Appendix 2 - KBLR response to the Masterplan Flood Risk and Drainage Strategy and Appendix 11.1 Lee Roxborough and McCloy Flood Risk Assessment

Catchment B Flood Basin. The area shown in red is the raised earthworks. Note the existing properties that are totally or partially surrounded by the raised earthworks.

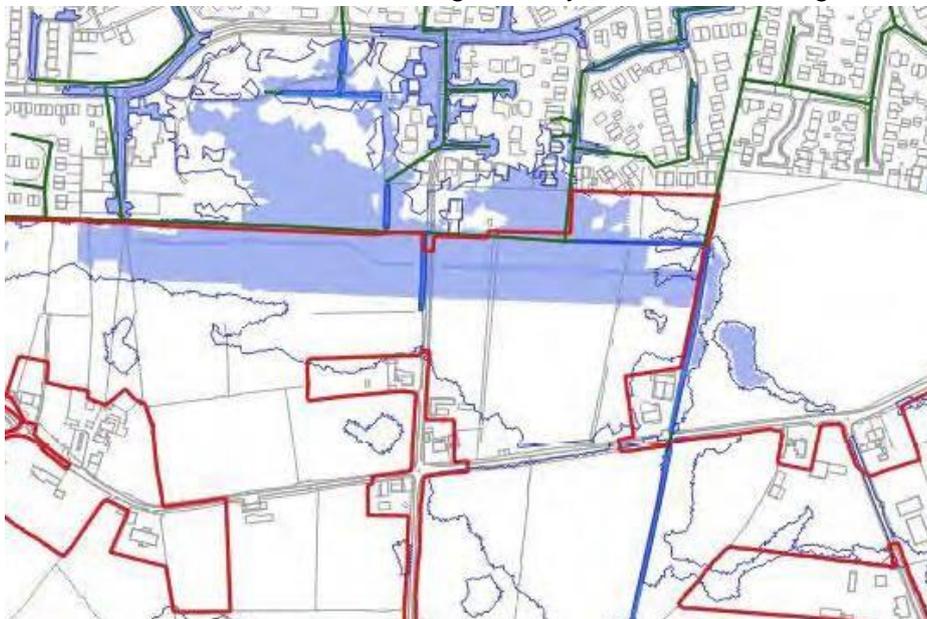
2.6 The drawing shows a flood basin with a capacity of 16,205 m³ Appendix 11.1 table 4.5. The estimated area of the flood basin is 400 x 20m. What is concerning is that water is channelled into the flood basin by employing raised earthworks to the south of the flood basin which are raised to a minimum level of 0.63 m above the predicted 100-year event water level. Ref page 40 of appendix 11.1. It is noted that no earthworks maximum height is given again demonstrating extreme design uncertainty. This statement leaves the developers with the freedom to raise earthworks significantly higher e.g. 1m+, with significant environmental detriment to the existing properties. This does not appear a credible solution given the impact the earthworks will have on existing property owners.

2.7 This artificial earth “berm” is not shown on the masterplan illustration. However, a number of existing properties at the North end of the site are shown in the referenced McCloy drawing at the back of Appendix 11.1 partially or completely surrounded by raised earthworks. This is a wholly unacceptable proposal. The authors of the report only state a minimum elevation. The actual height of these earthworks could be far higher (1 m+). This will place these properties at significantly elevated risk of flooding and will adversely impact visual amenity.

2.8 The proposed arrangement is shown below extracted from the McCloy drawing.

Figure 3-18: Predicted On-Site Flooding (3.3% & 1% AEP)

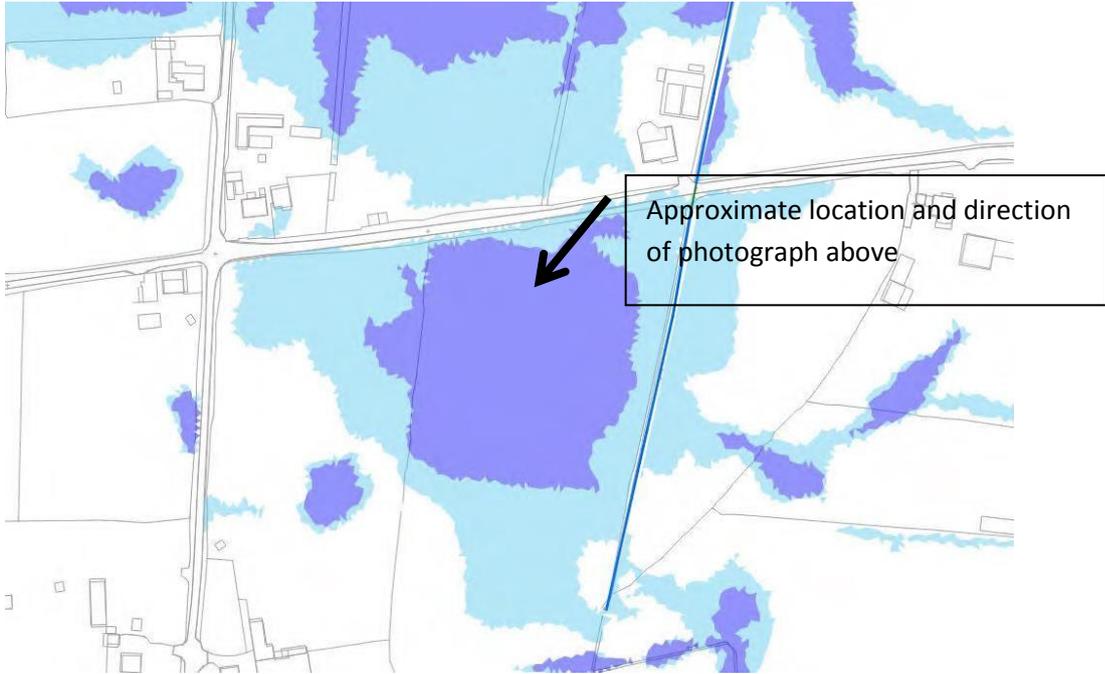
3.1 Appendix 11.1 section 3.10 deals with model validation. In this section the authors argue that pictures of “historic” flooding provided by “objectors” to the scheme in fact help validate the model. The authors imply that the two photos in question are from a one-off historic event. By comparing the photos with what is predicted in the model they claim the model then accurately predicts such a “historic” event and proves the model is sound.

“Model predictions have been reviewed at the two locations to form a degree of model validation; however, no dates were provided for the photographs and therefore no historical rainfall data could be obtained to determine the performance of the model under the same rainfall conditions. **The model predicts a significant area of flooding at the locations of the photographs for the 30-year event that corresponds with the general outlines of flooding in the photographs** and in the absence of more detailed historical data upon which to carry out verification, the model is considered to be sufficiently accurate.”

This statement beggar's belief, in effect the authors are claiming that the flooding shown in the two photographs is as a result of a 1 in 30-year rainfall event, and thus the model correlates with observed flooding.

It is abundantly clear to the local residents that the flooding shown in the photographs occurs routinely and regularly with major flood events such as those shown in the photographs occurring at least once every five years, so it is false to claim this as a one in thirty-year event as McCloy imply in their text.

This cynical misrepresentation of photographic evidence raises fundamental questions regarding the model accuracy and indeed the integrity of the whole report, as it appears to significantly underestimate the true extent of regular flooding that occurs in the development catchments.

Figure 3-20: Predicted On-Site Flooding (3.3% 1% AEP).

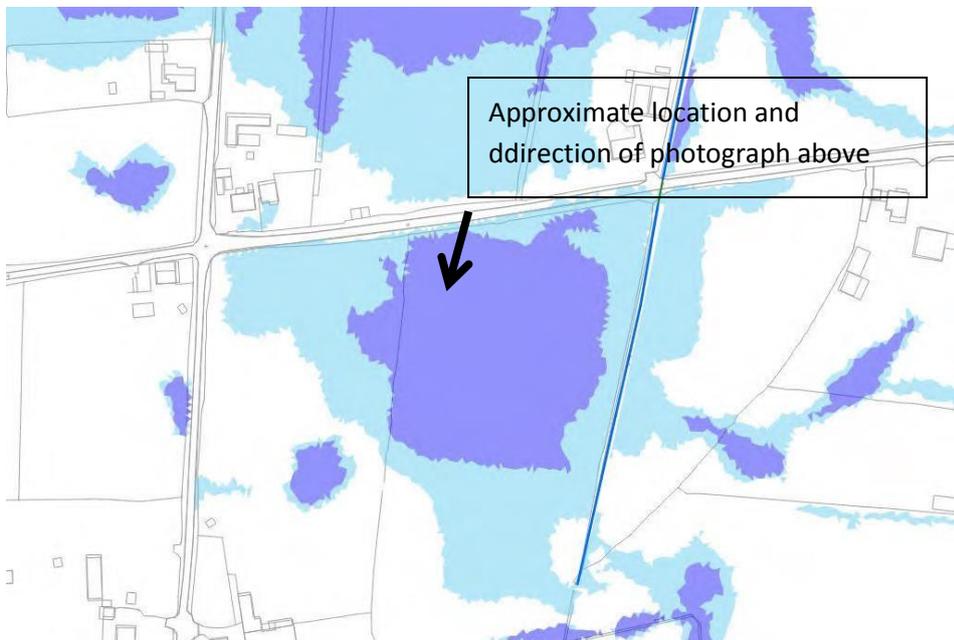
They also use the second photo below to “validate” the model.
